Fwd: CHD sewer service

SANITARY SEWER WYE CONNECTION

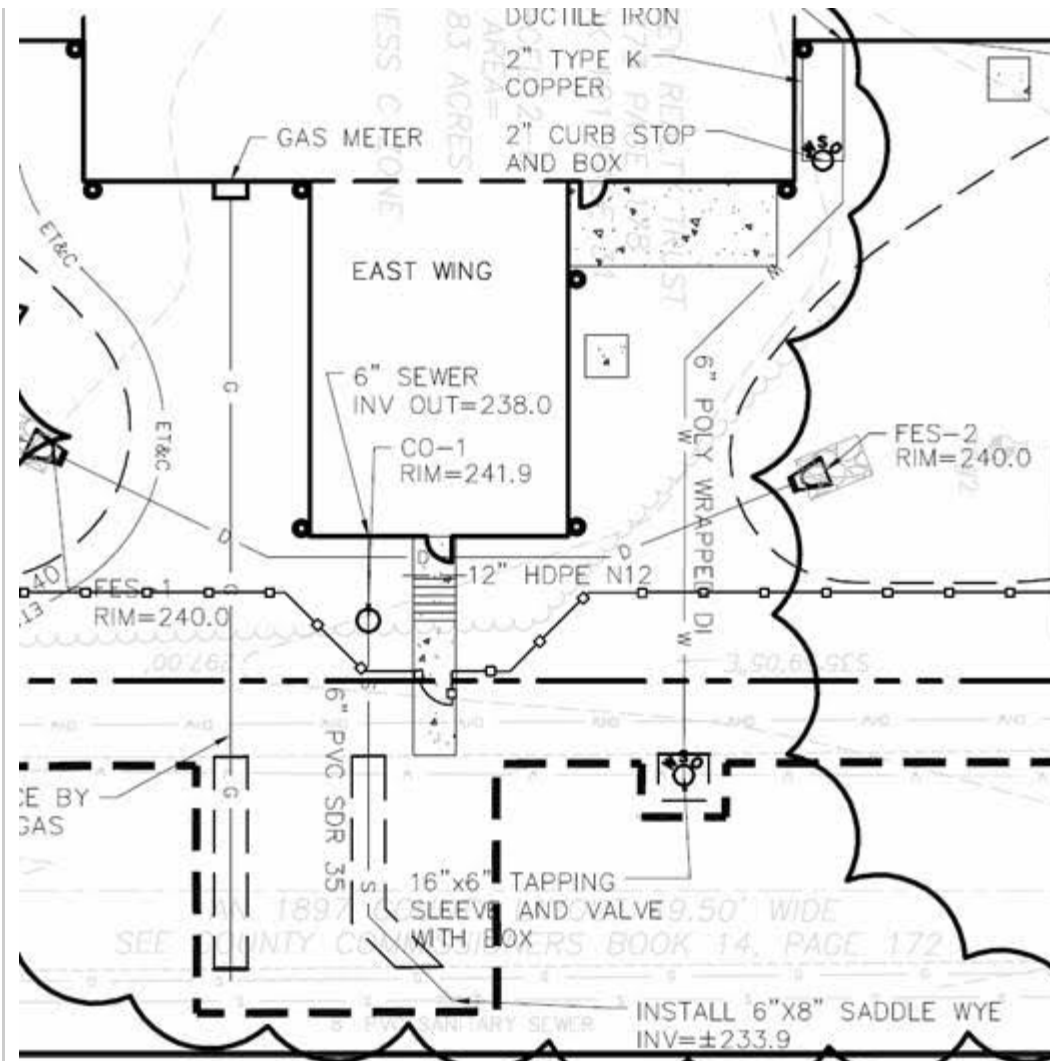
Attached is a detail of the sewer tie-in we are proposing. Tom Ciolek wants to do a 45 degree saddle wye at the main and a cleanout 10 feet outside the building. Let me know if you have any comments/revisions.

I do not generally require flowable fill. If the material you remove is suitable (we think it will be), then I am okay with you bedding the pipe in stone, backfilling with the suitable material that came out of the trench, and compacting it in one foot lifts. You must match the asphalt thickness in the road and there must be a foot of compacted gravel under the asphalt.
